Certification of Compliance with Safety Standards for the MELSEC iQ-R Series Safety CPUs

July 2026

■Relevant Models

R08SFCPU-SET, R16SFCPU-SET, R32SFCPU-SET, R120SFCPU-SET, R08SFCPU-S1-SET, R16SFCPU-S1-SET, R32SFCPU-S1-SET, R120SFCPU-S1-SET

■ Impact identification flowchart

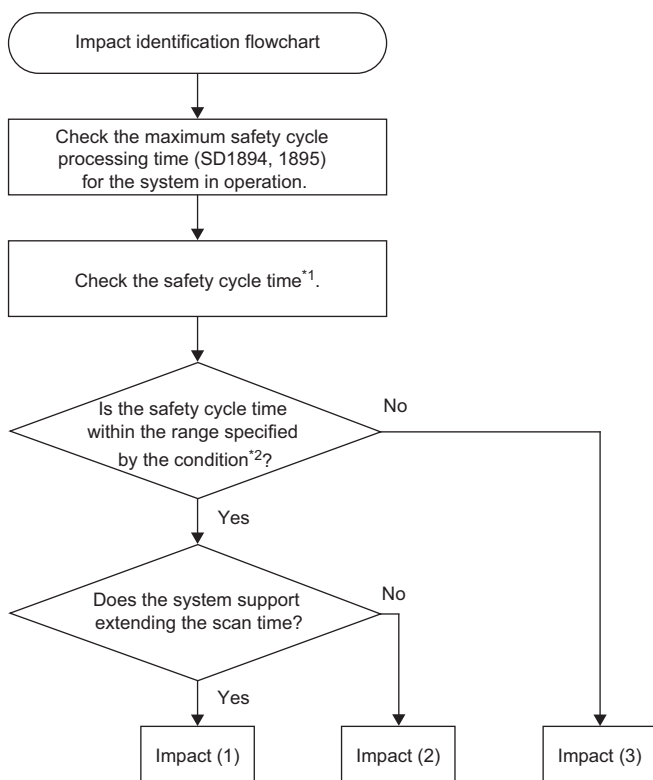
Since the new Safety CPU takes longer to process instructions than the existing Safety CPU, the new one also has a longer safety cycle time and scan time.

For systems currently in operation, before replacing an existing Safety CPU with a new Safety CPU, follow the flowchart below to review the details regarding each impact.

The necessary actions for each impact are described below. Modify the system as needed.

*1 The value set for [Safety Cycle Time] under [Safety Function Settings] in [CPU Parameters]

*2 Maximum safety cycle processing time (SD1894, 1895) of a Safety CPU $\times 1.5 < \text{Safety cycle time}$

Impact (2)

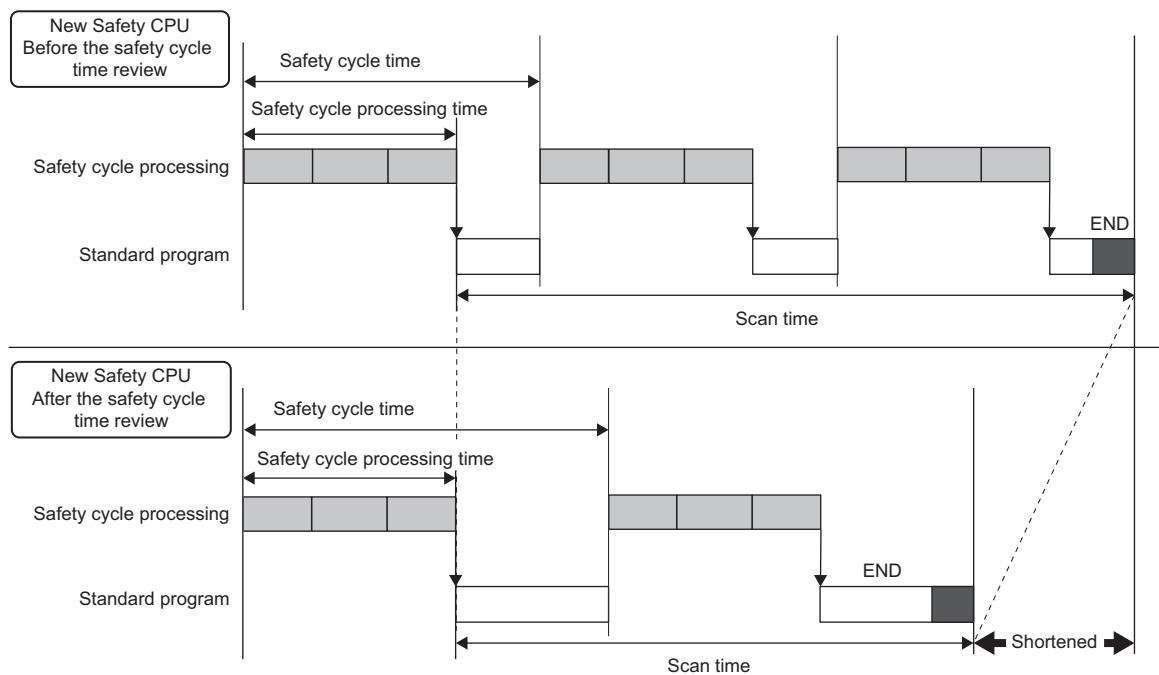
When the system cannot support extending the scan time, review the safety cycle time as shown below.

Extending the safety cycle time increases the amount of spare time available for executing a standard program, thereby reducing the scan time.

However, the transmission interval monitoring time and refresh monitoring time will need to be reviewed. Since the safety response time will change, review the safety distance if necessary.

Impact (3)

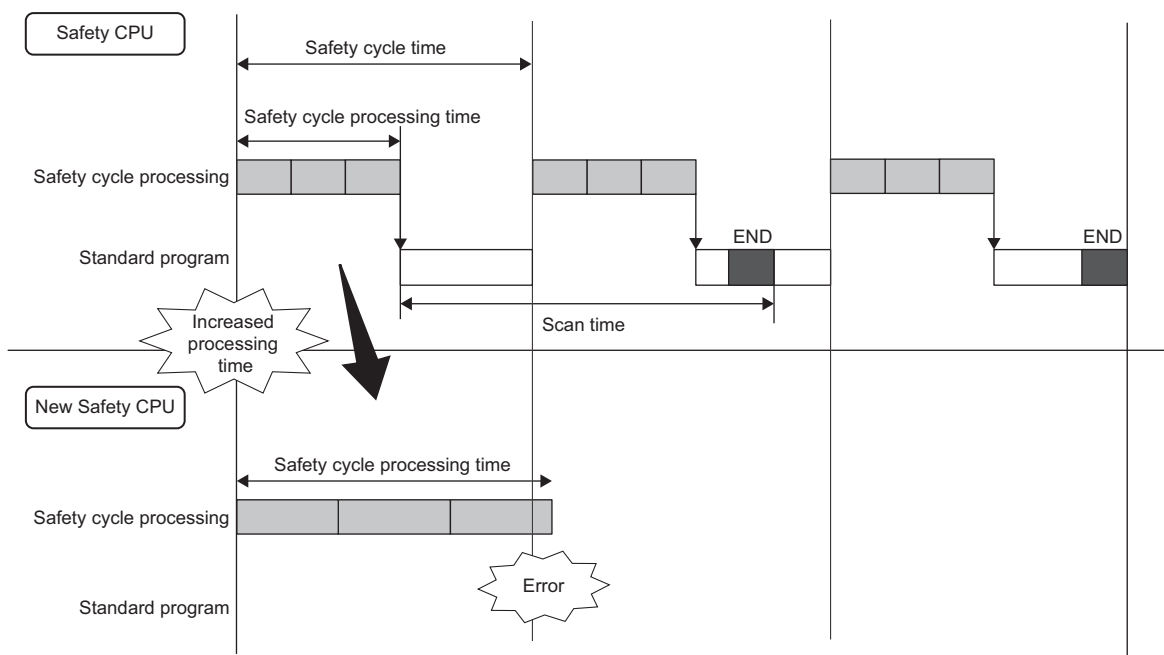
If the safety cycle processing does not complete within the safety cycle time, an error occurs. Review the safety cycle time. Consequently, the transmission interval monitoring time and refresh monitoring time will need to be reviewed. Since the safety response time will change, review the safety distance if necessary.
